TRANS/WP.29/GRE/2002/3/Add.1
5 February 2002

World Forum for Harmonization of Vehicle Regulations (WP.29)

PROPOSAL FOR DRAFT AMENDMENTS TO REGULATION No. 65

Addendum 1

Annex 2, the examples of the approval mark and the captions below, amend to read:

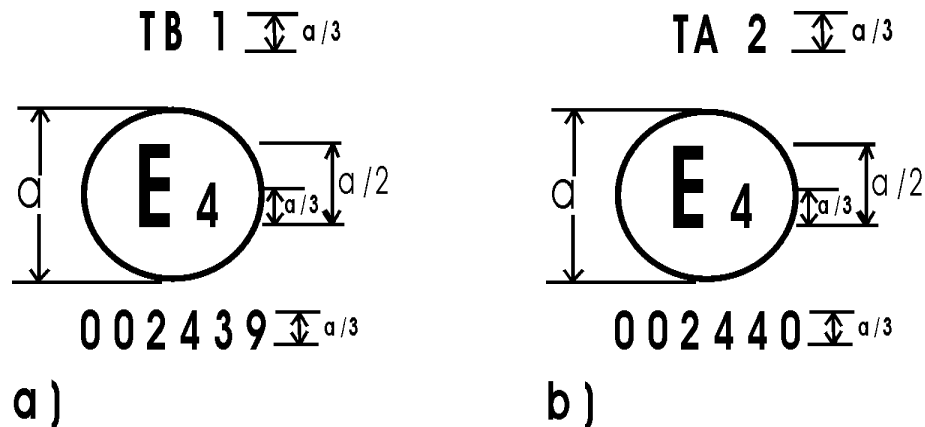
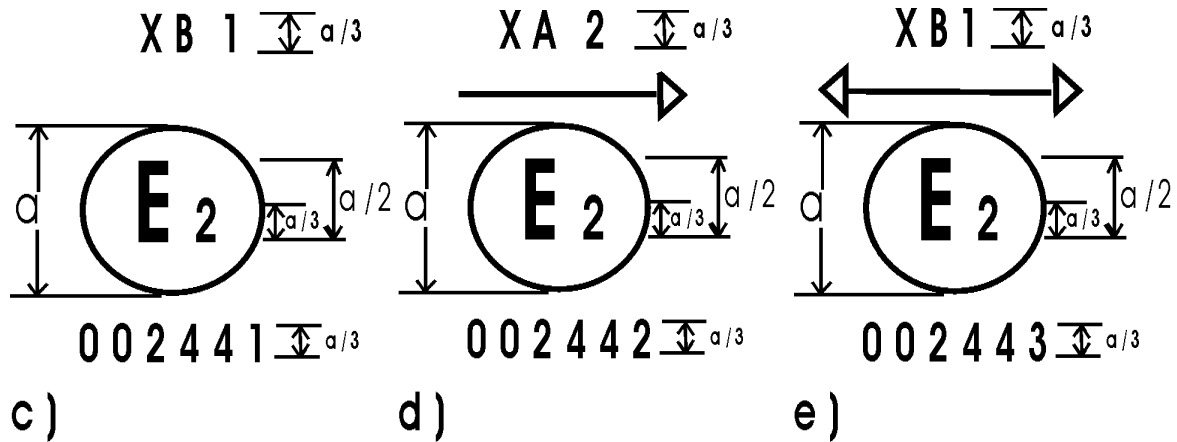
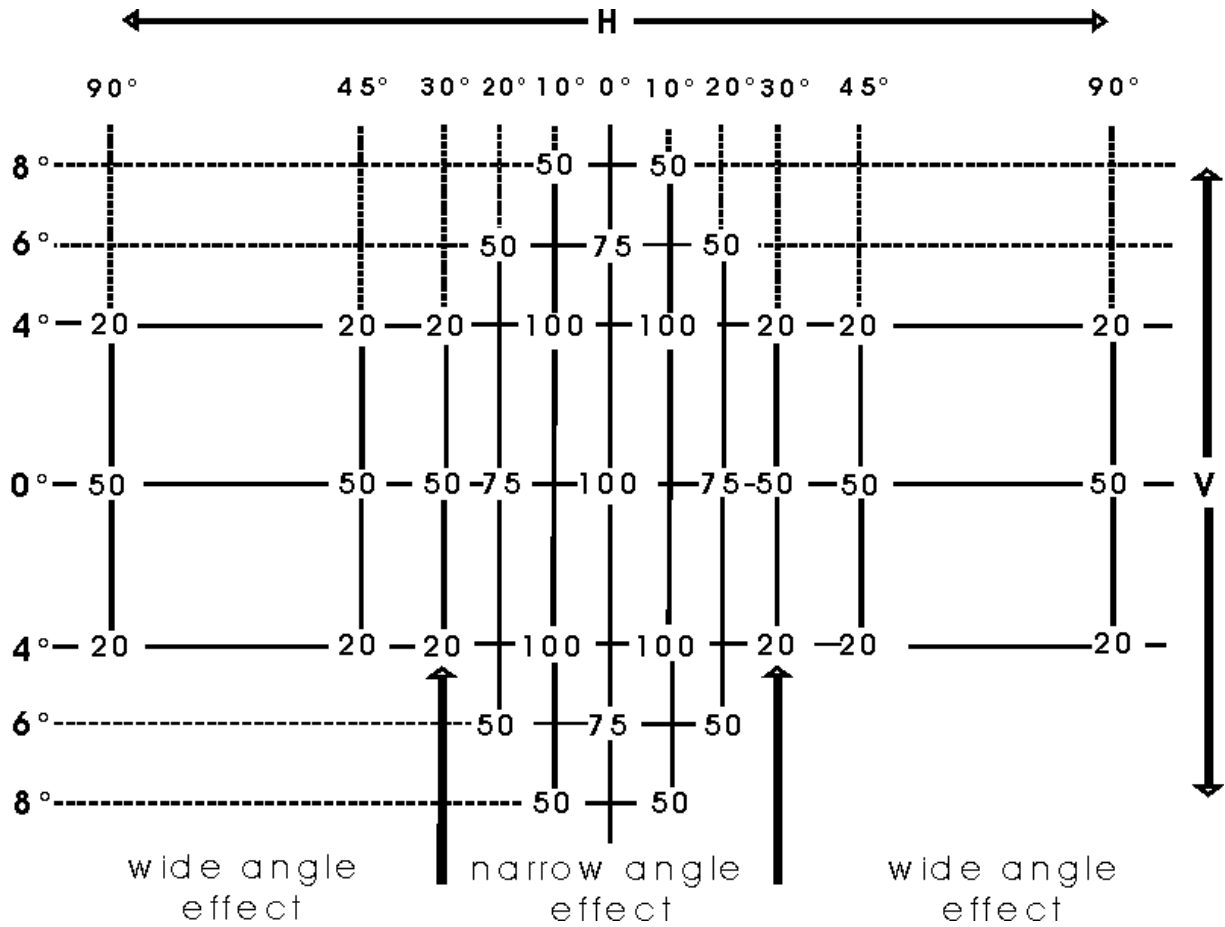
- a) a special warning lamp indicates that it has been approved in the Netherlands (E4) under approval number 002439. The approval number shows that the approval was granted in accordance with the requirements of the Regulation in its original form and that it is a blue rotating or stationary flashing special warning lamp of class 1 (TB 1).
- b) a directional flashing lamp indicates that it has been approved in the Netherlands (E4) under approval number 002440. The approval number shows that the approval was granted in accordance with the requirements of the Regulation in its original form and that it is a amber rotating or stationary flashing special warning lamp of class 2 (TA 2)."

- c) a directional flashing lamp indicates that it has been approved in France (E2) under approval number 002441. The approval number shows that the approval was granted in accordance with the requirements of the Regulation in its original form and that it is a blue directional flashing lamp of class 1 (XB 1).

- d) a directional flashing lamp indicates that it has been approved in France (E2) under approval number 002442. The approval number shows that the approval was granted in accordance with the requirements of the Regulation in its original form and that it is a amber directional flashing lamp of class 2 (XA 2).

- e) a directional flashing lamp indicates that it has been approved in France (E2) under approval number 002443. The approval number shows that the approval was granted in accordance with the requirements of the Regulation in its original form and that it is a blue directional flashing lamp of class 1 (XB 1).

The double side arrow indicates that the lamp has a wide-angle effect to both sides, which also indicates that the lamp could be mounted on both side of the vehicle."

- g) a directional flashing lamp indicates that it has been approved in Germany (E1) under approval number 002445. The approval number shows that the approval was granted in accordance with the requirements of the Regulation in its original form and that it is a blue directional flashing lamp of high maximum intensity class 2 category H (XHB 1).

- h) a directional flashing lamp indicates that it has been approved in Germany (E1) under approval number 002446. The approval number shows that the approval was granted in accordance with the requirements of the Regulation in its original form and that it is a blue directional flashing lamp of high maximum intensity class 1 category H (XHB 1). The double side arrow indicates that the lamp has a wide-angle effect to both sides, which also indicates that the lamp could be mounted on both side of the vehicle."
